Work Order ID 132407

Item Name: Quick Release Basket and Long Cargo Tube Mounting Provisions, Fits LH or RH

DART SERVICE INSTRUCTION

TO AMEND INSTALLATION INSTRUCTIONS D350-607-3 Rev.D,
INSTALLATION INSTRUCTIONS D350-607-4 Rev. C AND
INSTRUCTIONS FOR CONTINUED AIRWORTHINESS ICA-D350-607 REV. 6
REF TCCA STC: SH94-14
REF FAA STC: SR00213NY
REF EASA STC: EASA.10016996
REF BRAZILIAN STC: 2007S03-03/04/05/06

FIGURE 1: INSTALLATION OF D4775-041 FWD STRUT

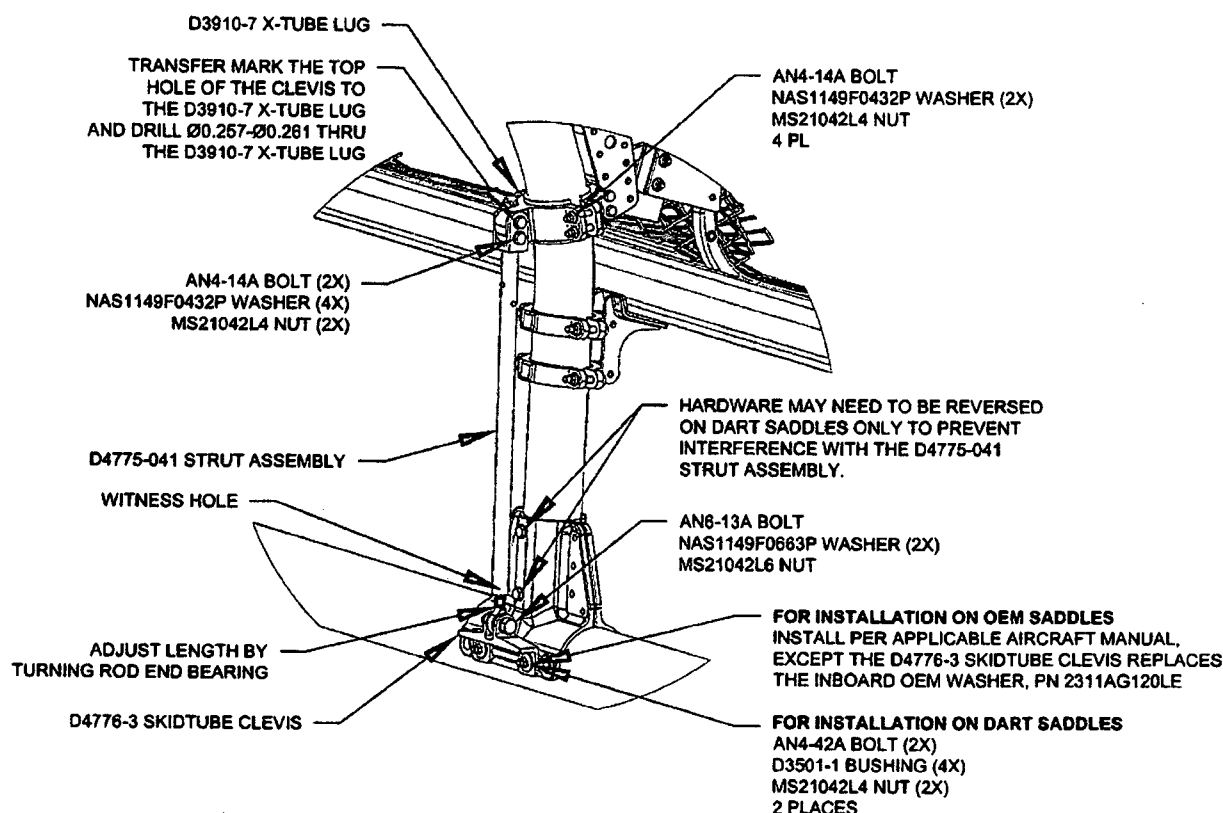
- 3.1 Substitute the Forward Lower D3910-5 X-Tube Lug with the D3910-7 X-Tube Lug as shown in Figure 1.
- 3.2 Install the forward D4775-041 Strut Assembly. Transfer mark from the upper hole on the clevis of the D4775-041 Strut Assembly to the D3910-7 X-tube Lug and drill thru the lug $\varnothing 0.257$ - $\varnothing 0.261$ as shown in Figure 1. Touch up chemical conversion coating per MIL-DTL-5541. Check the witness holes located at the bottom end of the D4775-041 Strut Assemblies to ensure that the thread from the rod end extends past the witness hole.
Torque MS21042L4/-4 nuts to 50-70 in-lbs (5.7-7.9 N-m). Torque MS21042L6/-6 nuts to 160-190 in-lbs (18.1-21.5 N-m).
- 3.3 Complete the installation in accordance with Installation Instructions D350-607-3 Rev. D or D350-607-4 Rev. C.
